Historic Preservation Commission Special Called Meeting Agenda

STAFF REPORT

CASE NUMBER: COA-0120-2025

REQUEST: Replace windows

Detail view of failed windows (typical)

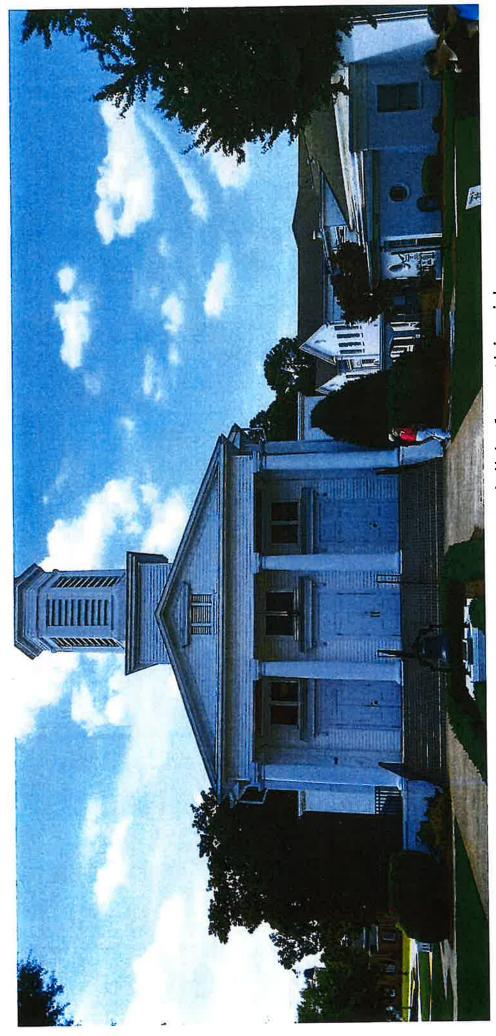
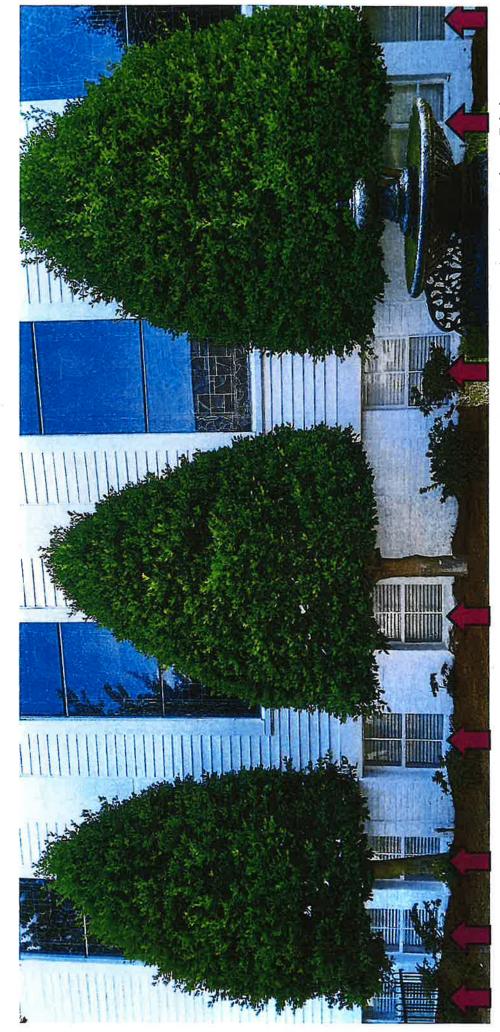
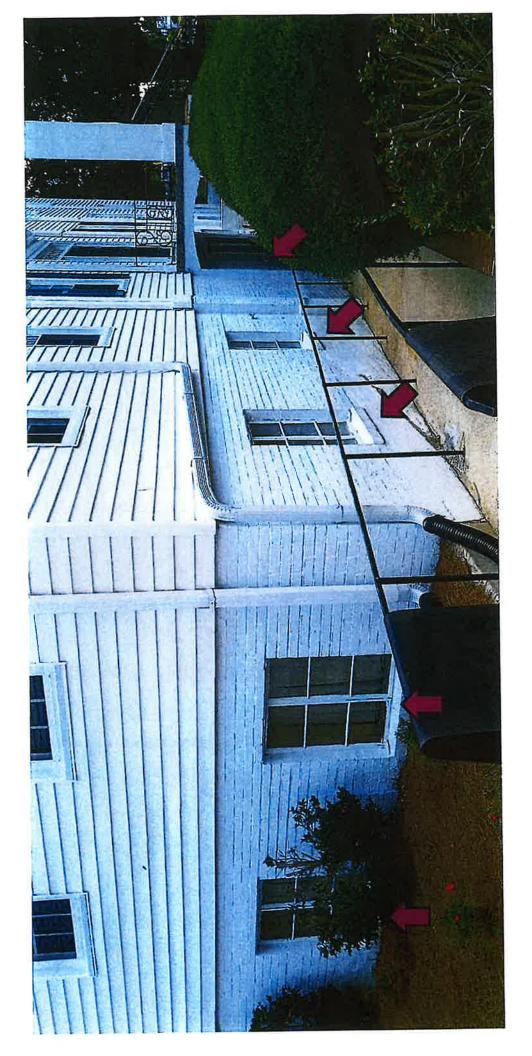
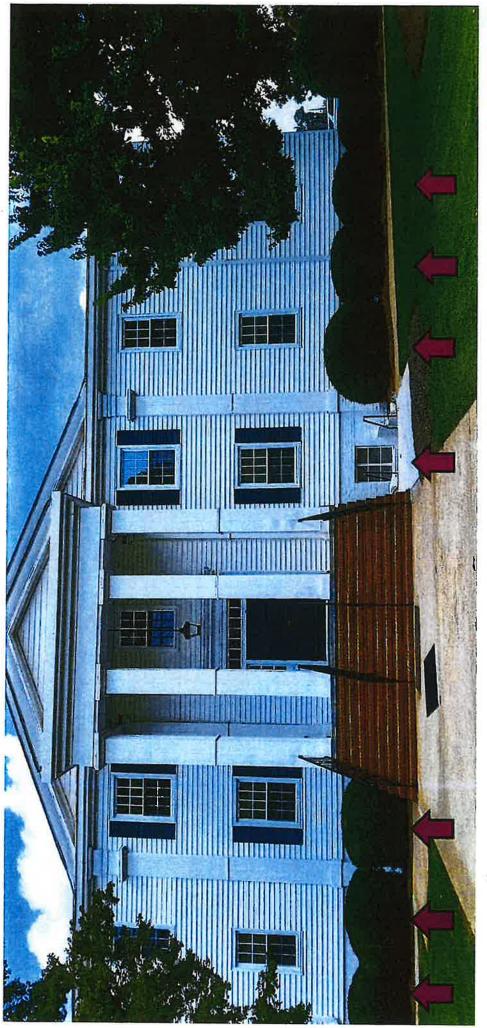
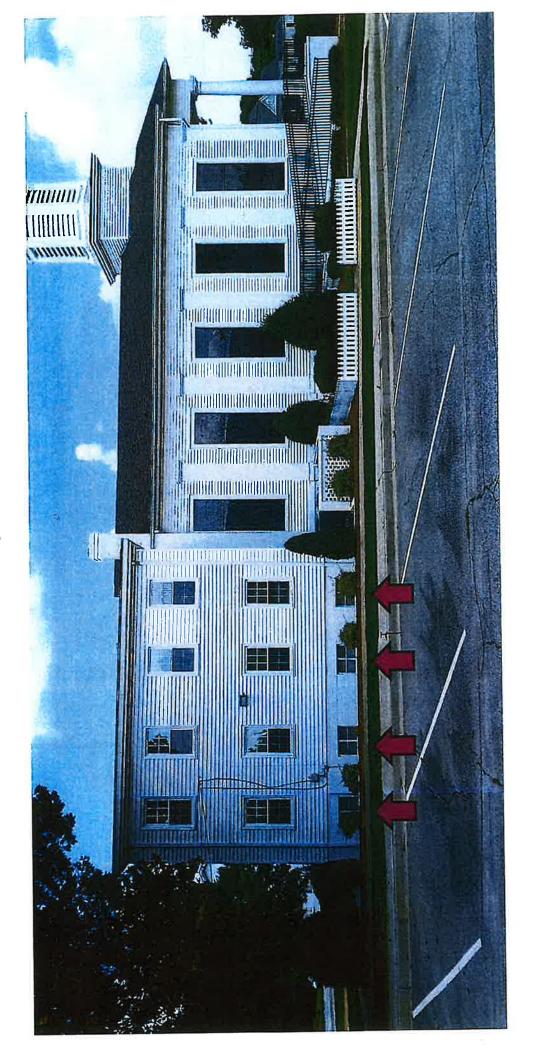
APPLICANT'S REQUEST: The applicant proposes to replace 29 existing steel frame, single-pane, casement windows in facility basement with double pane, vinyl frame, picture windows with simulated-divided-light grid to mimic existing windows. Existing windows are described as rusted, broken, and corroded beyond repair.

Basement windows visible in courtyard between Sanctuary and Education Bldg.

Basement windows largely screened from view by landscaping

STAFF RECOMMENDATION: Due to the unavailability of window repair contractors and the costs associated with wood replacement windows, Staff recommends approval of the application as an undue hardship, with the following conditions:

- 1. The replacement windows shall be the same size as the existing windows and the simulated divided light grids shall match the existing window grids.
- 2. If physically possible given the window construction, add the simulated divided light grids to the existing vinyl windows for visual consistency of all windows on the building.
